Th 15a

Re: Navy Monitoring Plan, "Homeporting" Project, Coronado, Submitted
in Compliance with CD-95-95

**RESPONSE TO REGULATOR COMMENTS TO DRAFT FOCUSED REMEDIAL INVESTIGATION/RCRA FACILITY INVESTIGATION
WORK PLAN, IRP SITE 1, OUTFALLS 9 – 15, SHORELINE SEDIMENTS,
NAVAL BASE CORONADO NORTH, SAN DIEGO, CALIFORNIA
CTO-0148**

<p>Focused RI/RFI Work Plan</p> <p>Figure 4-5</p> <p>Proposed Well Locations</p>	
<p>Naval Base Coronado-North, San Diego, CA</p>	
	<p>Bechtel National, Inc. CLEAN II Program</p>
<p>Date: 10/14/97 File No: 148L2532 Job No: 22214-148 Rev No: 1</p>

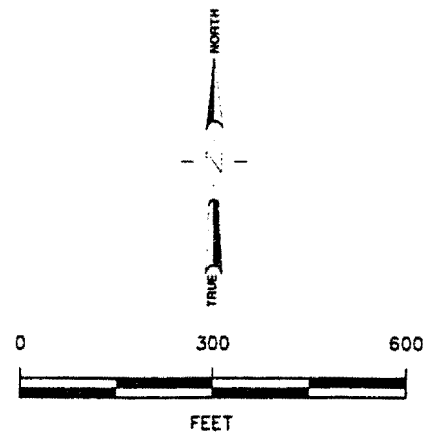
Comment 4: Section 4.4, page 4-6. Provide the existing onshore monitoring wells and the location of Building 66 on Figure 4-3.

Response 4: Figure 4-3 will be revised to show the location of building 66 and the associated groundwater monitoring wells.
